LIC-07-0084
October 5, 2007

SUBJECT: Fort Calhoun Station, Unit No. 1, License Amendment Request, "Change to Diesel Generator Surveillance Testing"

**Omaha Public Power District's
Evaluation of the Proposed Change**

“Change to Diesel Generator Surveillance Testing”

SKETCH 1

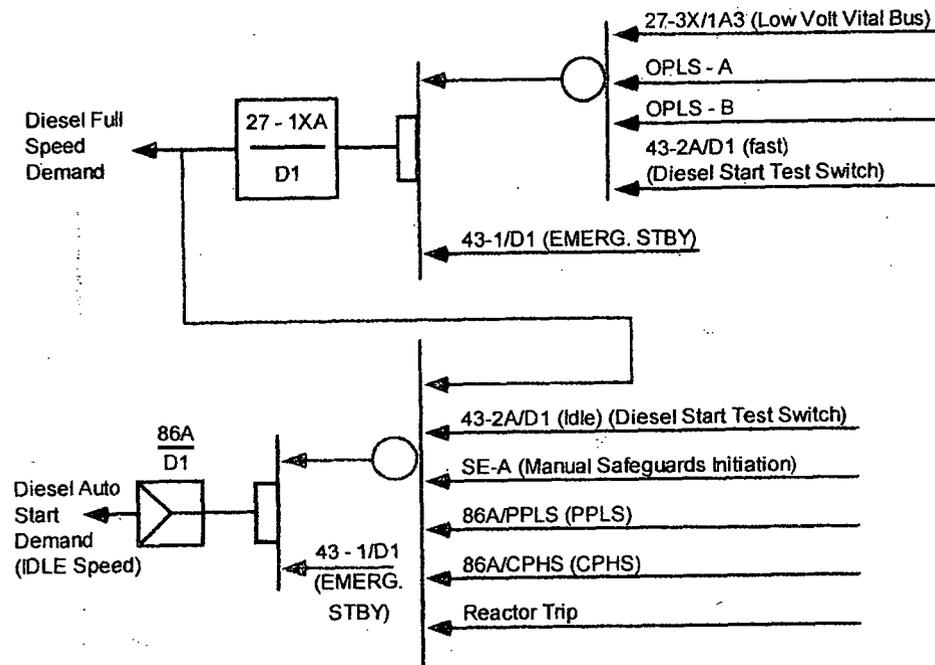
This LAR addresses the previous NRC concerns of removing the ESF start signals. The ESF signals (PPLS and CPHS) as proposed will provide DG full speed starting. DG full speed starting will also occur on any safety bus undervoltage condition. Sketches of the existing FCS DG starts and the proposed FCS DG starts are provided in Attachment 3 for information purposes.

Modification EC 33661 will remove the anticipatory (idle speed) DG start signal from the RPS on a reactor trip, such that the DGs start and accelerate to full speed on an undervoltage condition or an ESF signal. Removal of the RPS anticipatory (idle speed) DG start signal does not change the function of the DGs as they still provide emergency power to their respective buses when required.

This LAR responds to those previous NRC concerns of removing the ESF start signals. The ESF signals (PPLS and CPHS) as proposed will provide DG full speed starting. DG full speed starting will also occur on any safety bus undervoltage condition. Sketches of the existing FCS and proposed FCS DG starts are provided in Attachment 3 for information purposes.

- A. Set the governor droop setting to zero which will eliminate the use of the governor travel limit switch.
- B. Disable the idle-to-full speed acceleration signal to provide improved speed control of the engine.
- C. Disable the RPS automatic anticipatory start signal to eliminate no-load diesel operation.
